LINOTYPE IMPROVEMENT INFORMATION SHEET

NO. 329

FIRST ELEVATOR JAW LINE STOP E-5878

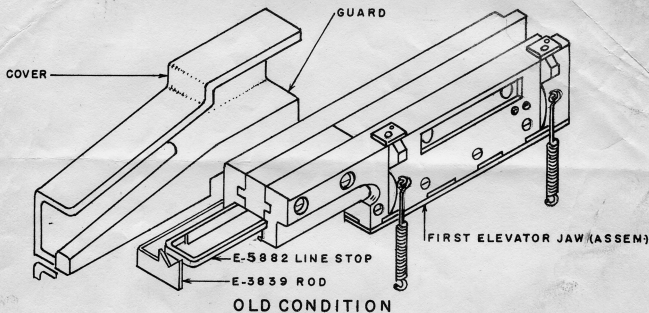
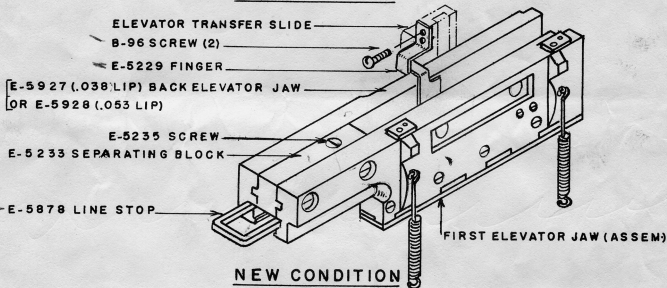
The type of automatic sliding line stop formerly used only on Comet Linotypes is now applied to all new Models 5, 29, 30, 31, 32, 33, 34, 35 and 36. This line stop has a projection which rides above the top of the first elevator back jaw. A small finger attached to the transfer slide, contacts this projection to return the line stop to normal position. This eliminates the former line stop return rod which projected from the end of the face plate and also its guard and cover.

Can be applied to Outstanding Linotypes by using finger E-5229, two screws B-96, Line stop E-5878, first elevator back jaw E-5927 (.038 lip) or E-5928 (.053 lip), separating block E-5233 and screw E-5235. If the first elevator back jaw with detent for quadder machines is wanted, apply E-5939 (.038 lip) or E-5940 (.053 lip). See Improvement Sheet No. 327.
